Water Heater Deflector

Bulletin Type:	SRP	Publication Date:	September 2021
Bulletin #(s):	21-031	Make(s):	SC
Job Code(s):	<i>If affected unit has warranty remaining, submit your claim following the normal process</i>	Model(s):	SuperLite TT
Flat Rate(s):		Model Year(s):	2021

Incident:	Refrigerator Exhaust Vent Installed Above Water Heater
Affected Units:	2021 Starcraft Superlite TT
Parts List:	4 Ea- RIVET, 3/16" BLIND RIVET (FASTENAL# 1141505 – Purchase Locally) 1 Ea (JAYCO# 2016727) – DEFLECTOR, WATER HEATER DOOR VENT)
Misc. Tools & Supplies:	1 Ea – No.11 DRILL BIT (0.191" DIA) 1 EA- POP RIVET TOOL 1 EA- DRILL 1 EA- SEALANT
Parts Return Information:	N/A

Fig 2

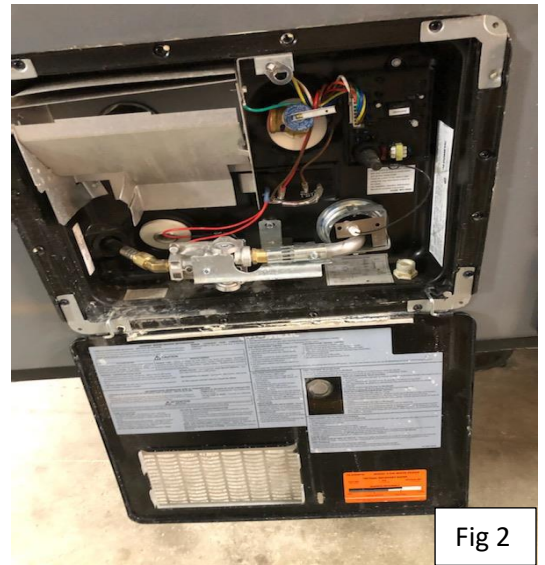
2. Open access door to the Water Heater shown in Fig 2.
3. Remove water heater door from water heater.
 - a. a.) With door at 90 degrees to unit, knock door forward using hand or rubber mallet at rear hinge piece in Fig 3. Keep hinge pieces for re-installing later shown in Fig 4
